Addenda No. 3

PREPARED BY: Michael Gumbel

SUBJECT: OR 99/238 Paving (Grants Pass) Section
Rogue River/Jacksonville Highway
Jackson County
Paving & Drainage Project
(Bids to be opened and read January 22, 2009)

SHEET NO. **8**

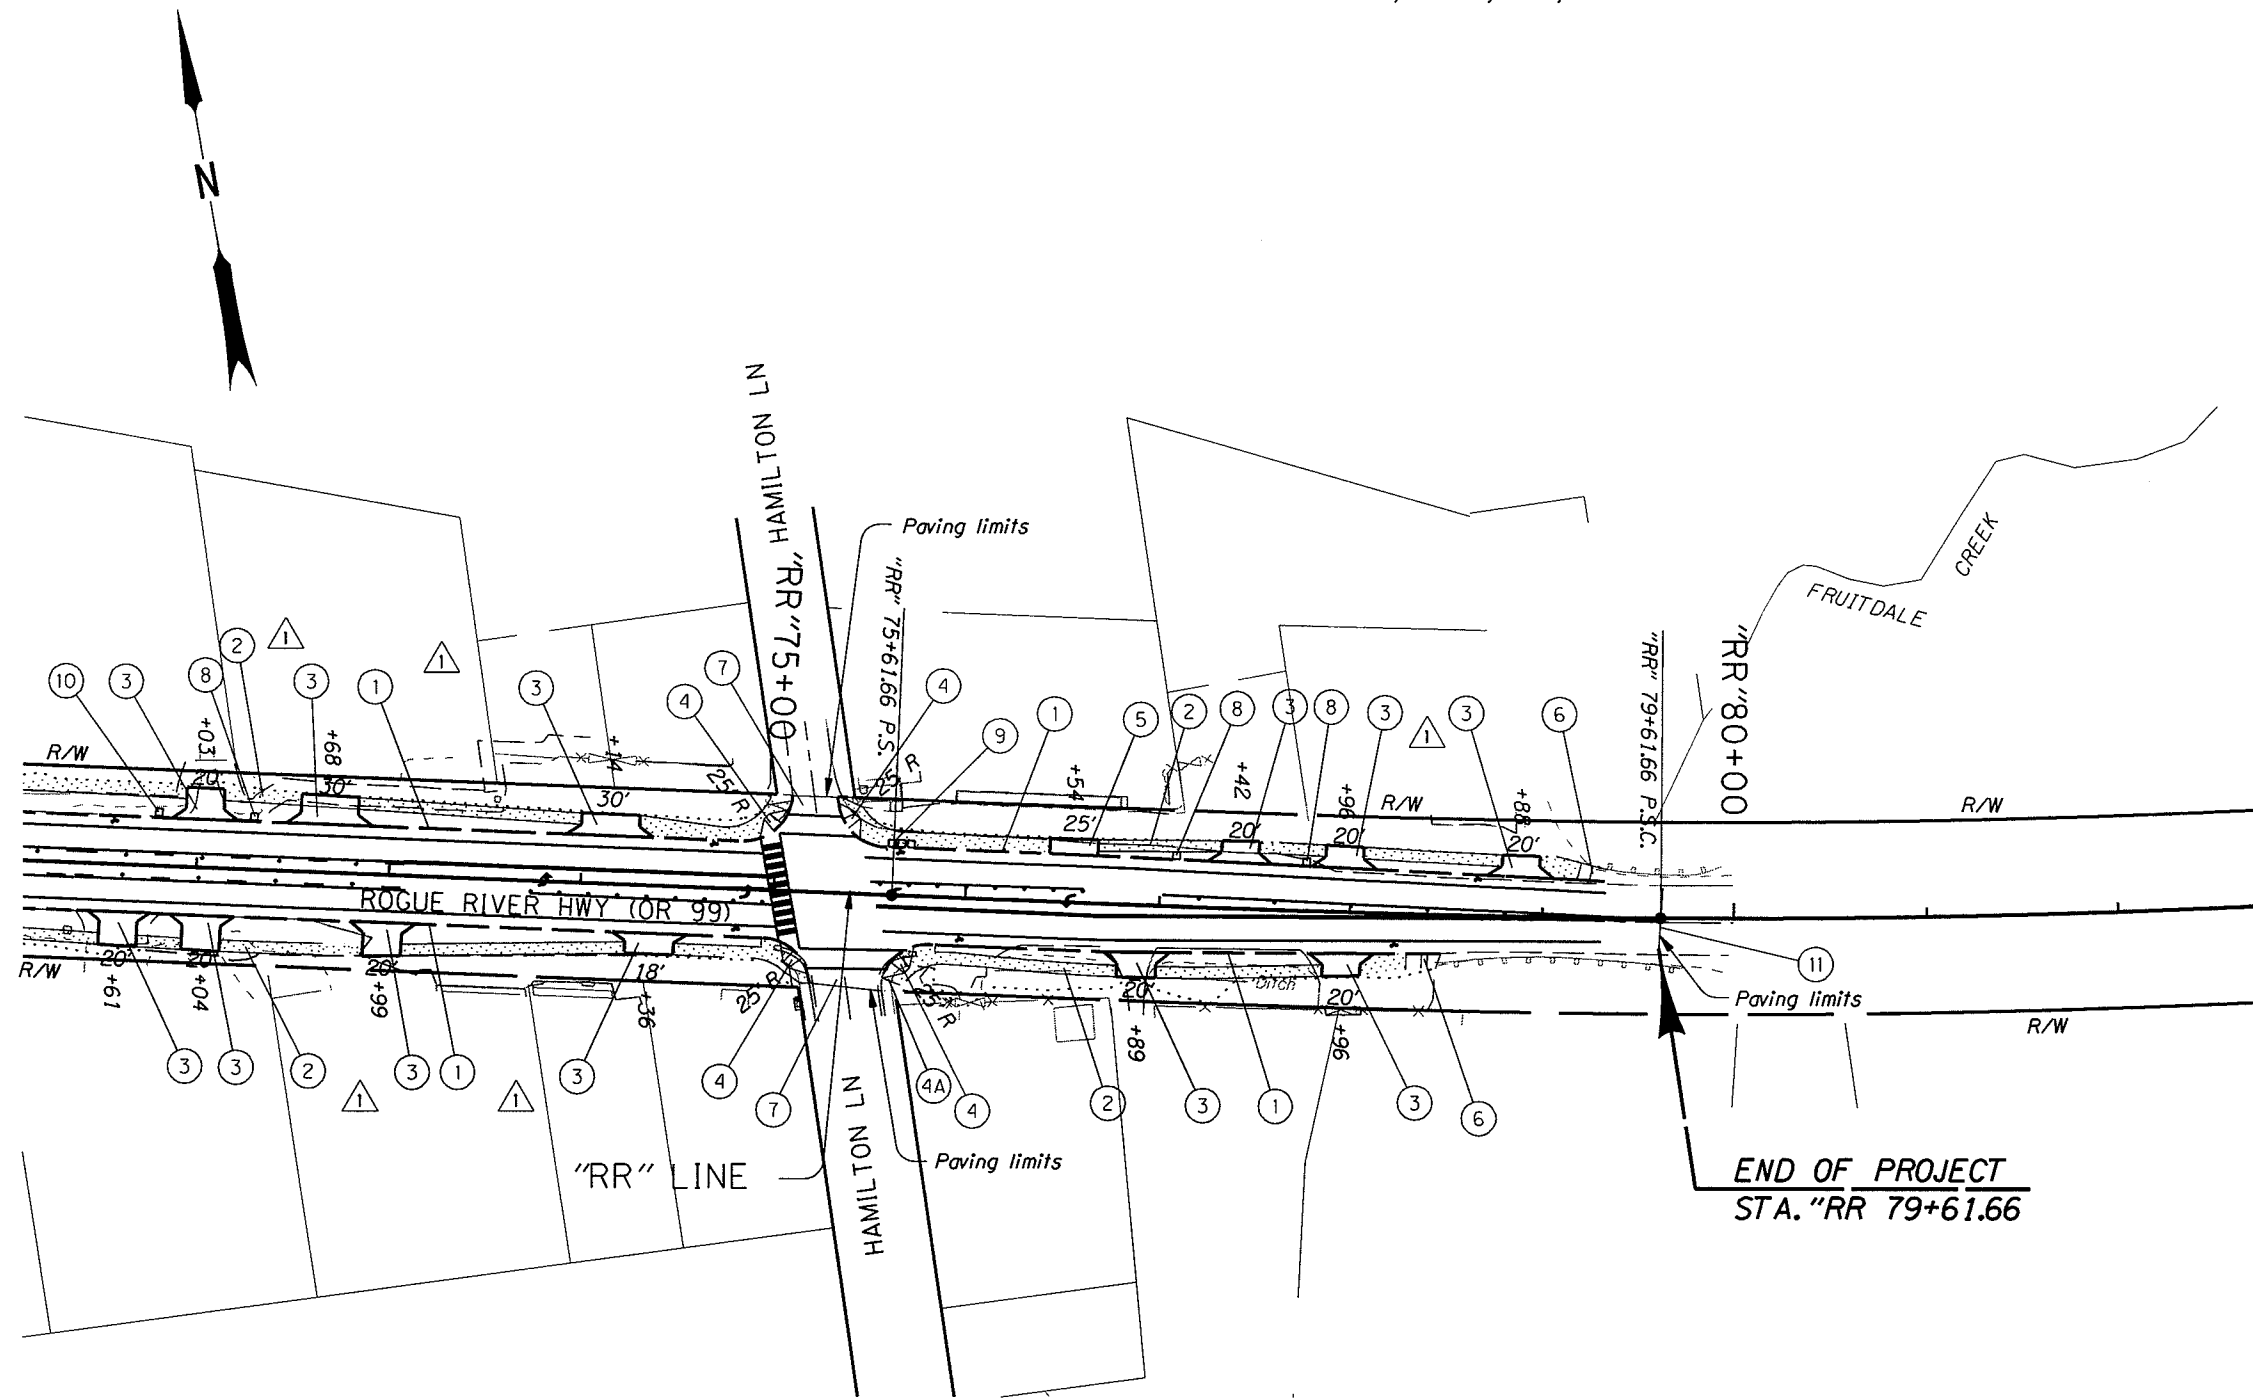
| Rev. No. | Description | Date | Engineer |
|----------|------------------------------|---------|--------------|
| ① | Remove extra note 11 bubbles | 1-12-09 | Chris Zelmer |
